Sec. 4-115. - General exceptions and amendments applicable to all technical codes.

Sec. 4-120. - Specific Amendments to the 2021 International Building Code.

Figure 307.4

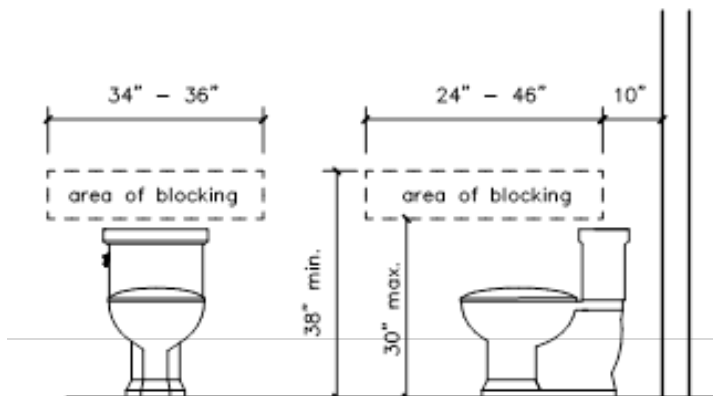
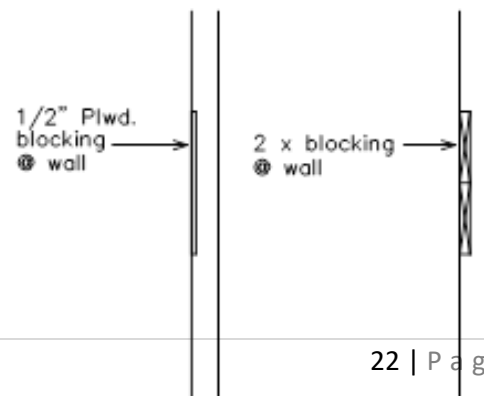
R307.3 Blocking. Required at one toilet at grade level. Blocking per Sec. R307.4 and Figure 307.4, shall be installed at rear wall and one wall adjacent to toilet at the lowest living level where a toilet is provided.

R307.4 Blocking. Blocking may be 1/2" plywood or equivalent or 2 x solid wood blocking flush with wall.

Figure R602.6.1; delete the figure and insert the following figure:

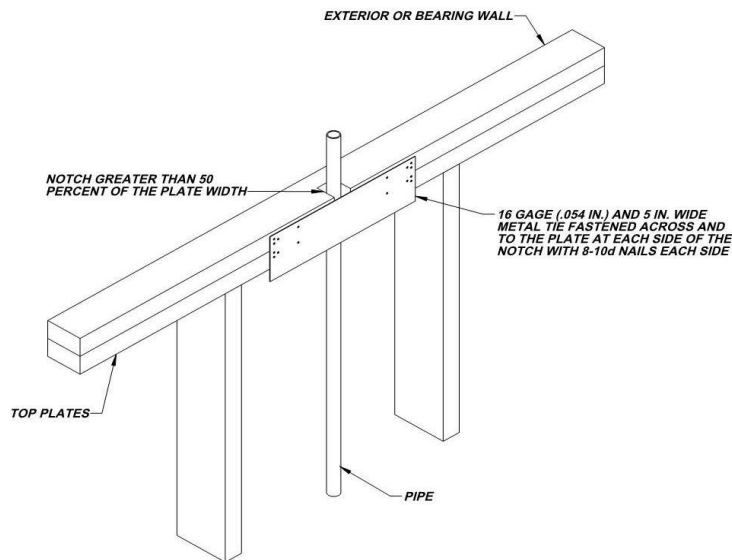
R602.6.1 Drilling and notching of top plate. When piping or ductwork is placed in or partly in an exterior wall or interior load-bearing wall, necessitating cutting, drilling or notching of the top plate by more than 50 percent of its width, a galvanized metal tie not less than 0.054 inch thick (1.37 mm) (16 Ga) and ~~1 ½ inches (38 mm)~~ 5 inches (127 mm) wide shall be fastened across and to the plate at each side of the opening with not less than eight 10d (0.148 inch diameter) having a minimum length of 1 ½ inches (38

mm) at each side or equivalent. Fasteners will be offset to prevent splitting of the top plate material. The metal tie must extend a minimum of 6 inches past the opening. See figure R602.6.1. {remainder unchanged}

Section 503.4.1 Traffic Calming Devices. shall be amended as follows:

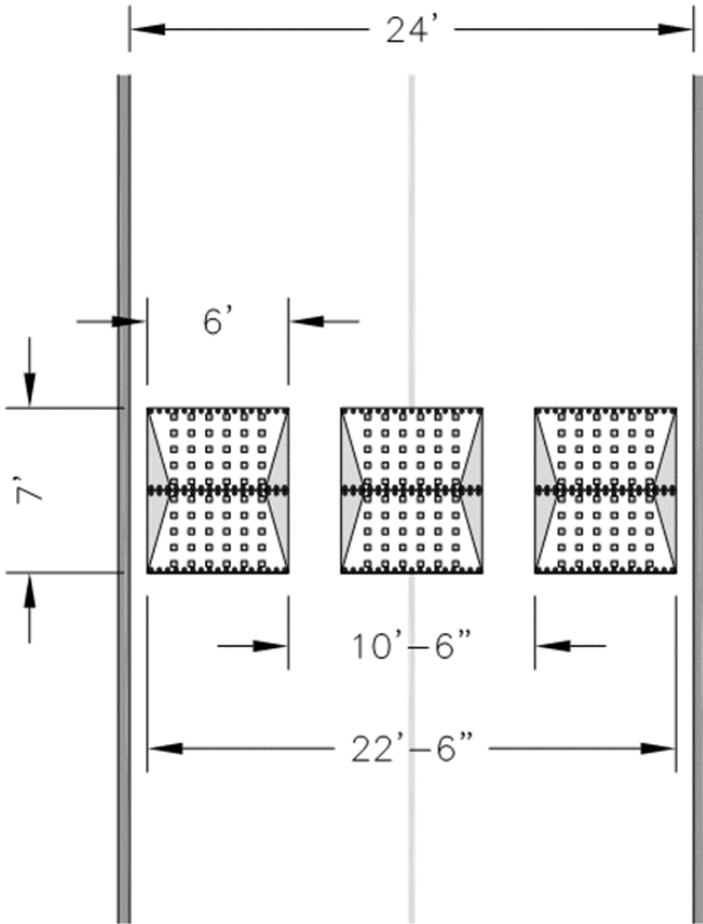
Section 503.4.1 Speed Cushions across fire apparatus access roads shall meet the design requirements specified in the Keller Unified Development Code as noted below:

1. Dimensions 3"x6'x7'
2. Entrance and Exit Gradient: 1:15
3. Side Gradient: 1:3
4. Material: Compression molded 100% recycled natural rubber and polyurethane.
5. Advance Notification: Some advance notification of the speed-reducing devices required.
6. Spacing: Minimum spacing of 200 feet between speed cushions.

WATER CONSTRUCTION DETAILS RESIDENTIAL FIRE SPRINKLER SERVICE	REVISION DATE: 8/2/2012
		SHEET: W-15

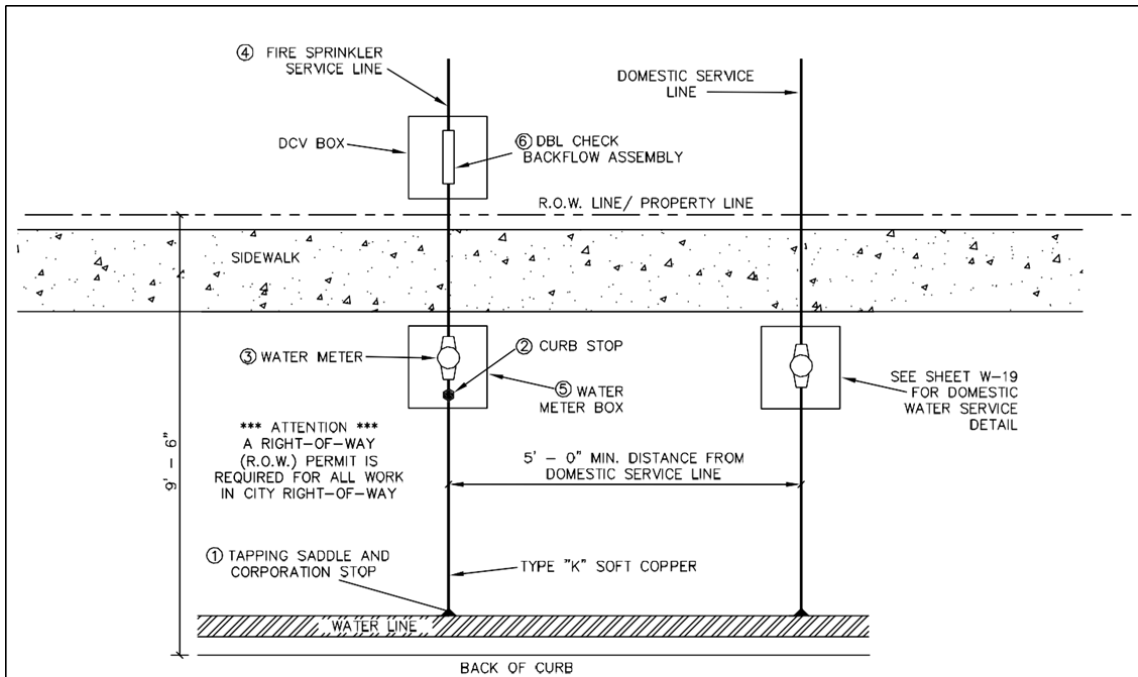
903.3.1.3.1 Residential sprinklers. Unless specifically allowed by this Code, residential sprinkler systems installed in accordance with NFPA 13D or NFPA 13R shall not be granted exemptions or reductions, commonly known as “trade-offs” permitted by other requirements of this Code. Additionally, residential sprinkler systems installed in accordance with NFPA 13R shall include attic protection. Water supply for residential fire sprinkler systems shall be provided by way of a separate tap and meter as detailed in the Keller Unified Development Code as noted below:

ADD: Figure: 25 TAC §265.186 (e) (6)

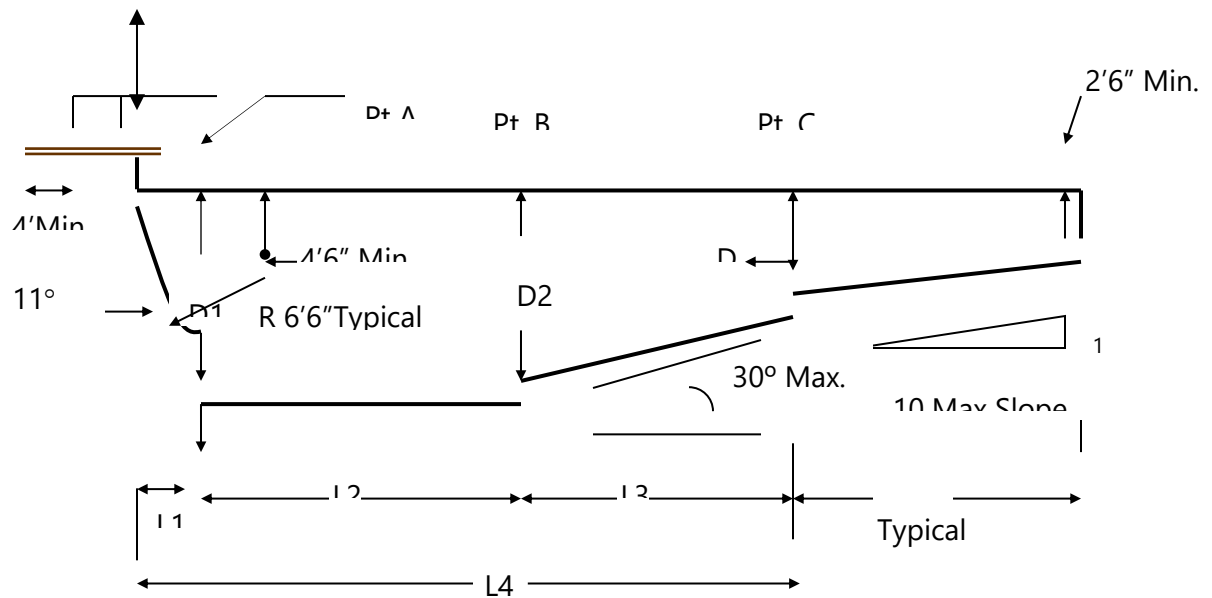
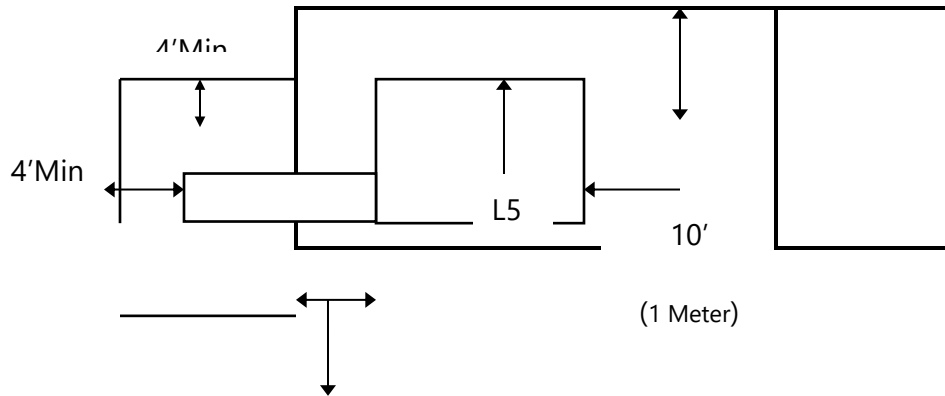
402.12 Water envelopes. The minimum diving water envelopes shall be in accordance with ~~Table 402.12 Texas department of State Health services, Administrative Code Title 25, Chapter 265, Section 186 (e) and Figure: 25 TAC 256.186 (e) (6).~~ (Delete Table 402.12 and Figure 402.12)
